## Determination 2008/9

### Determination about the code compliance of a barrier that has been built in accordance with a building consent, at Hutt Valley High School, Woburn Road, Lower Hutt

Figure 1: Section through the barrier

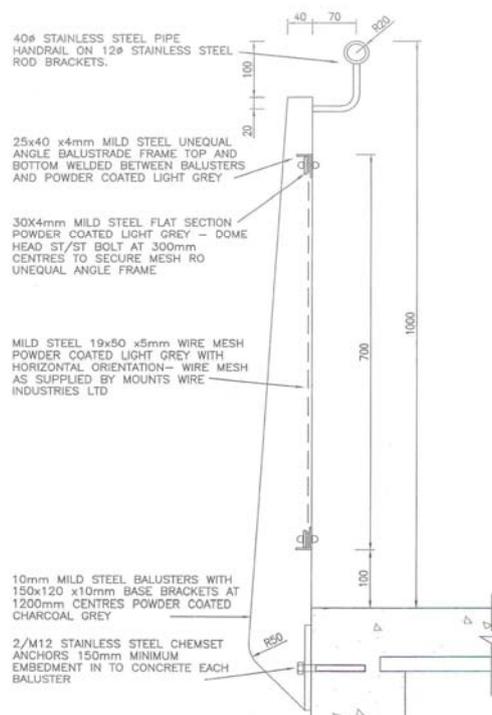
External and internal [barriers] do not comply with NZBC F4 Safety from falling – Being the opening at the top of the balustrade is greater than 100mm as required by Table 2.

- 6.3 The dispute concerns whether the building is likely to be frequented by children under six years of age, and if it is, whether the height of the toeholds and size of openings in the barriers are code compliant. The overall height of the barriers is not in dispute.

- 6.4 If children under six years of age are likely to frequent the building, Clause 1.2.1(b) of Acceptable Solution F4/AS1 does not allow any toeholds between “150 mm and 760 mm above floor level”, and Table 2 of Acceptable Solution F4/AS1 does not allow any openings larger than 130mm for children between the ages of 4 and 5, and openings no larger than 100mm for children under 4 years of age.

6.5 The barrier as approved in the building consent, and as built, has

- a toehold 800mm above floor level
- openings in the barrier greater than 100 and 130mm.

6.9 I accept the consultants submission and I am therefore of the view that the building is unlikely to be frequented by children under six years of age. I conclude that the barrier as consented, and as constructed, complies with the Building Code Clause F4 "Safety from falling", and the Acceptable Solution F4/AS1.

- 7.1 In accordance with section 188 of the Act, I determine that the territorial authority is to reverse its decision to issue the notice to fix dated 7 June 2007.
